**BROWNS FERRY NUCLEAR PLANT (BFN) - UNITS 1, 2, and 3 -
EMERGENCY PLAN IMPLEMENTING PROCEDURE (EPIP) REVISIONS**

EMERGENCY PLAN IMPLEMENTING PROCEDURE (EPIP) REVISIONS
EPIP-1

EMERGENCY CLASSIFICATION PROCEDURE

REVISION 36

1.2-G

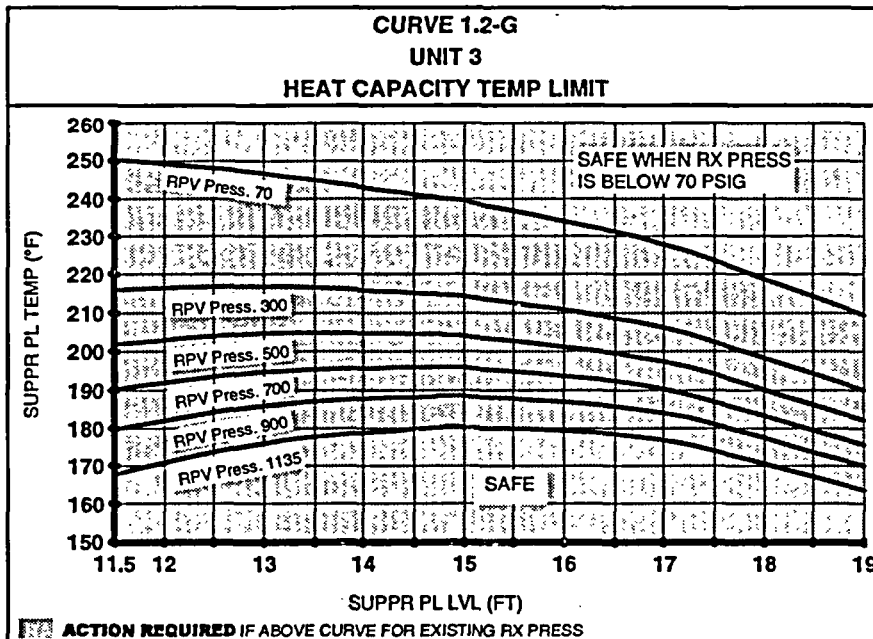
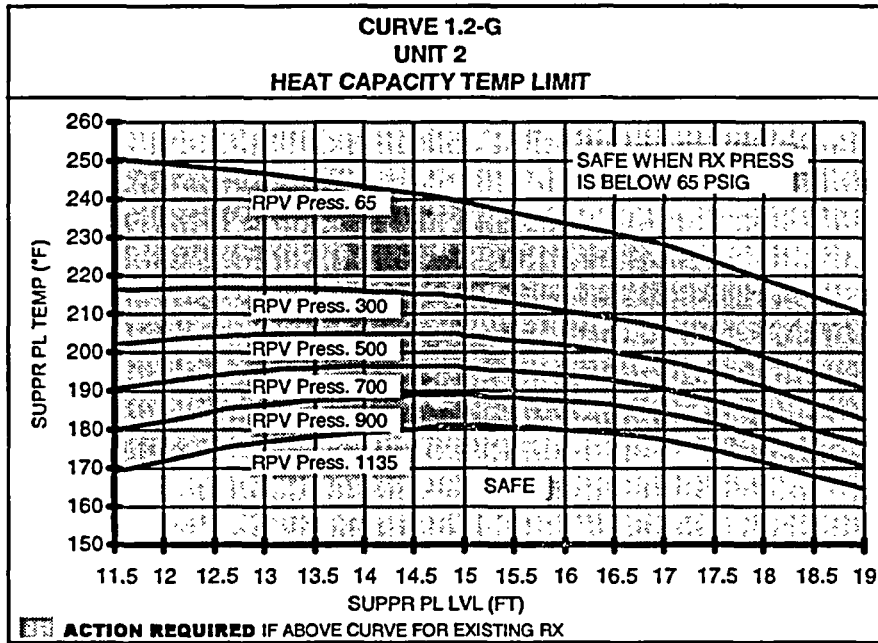
- IC-47 EPIP 1, rev. 36 is being conducted to modify information that supports EAL 1.1-G1, 1.1-G2, 1.2-G, and 1.5-S. This revision incorporates changes resulting from engineering calculations that support Minimum Alternate RPV Flooding Pressures (MARFP), Minimum Steam Cooling Reactor Water Level (MSCRWL) and Heat Capacity Temperature Limits. Revisions to these calculations were conducted in support of the EOI Program Manual Revision 23 (U3C12).

- **Suppression Pool temperature exceeds HCTL.
Refer to curve 1.2-G.**
- **Reactor water level CANNOT be restored and maintained
at or above:**

Unit 2	-185 IN.
Unit 3	-180 IN.
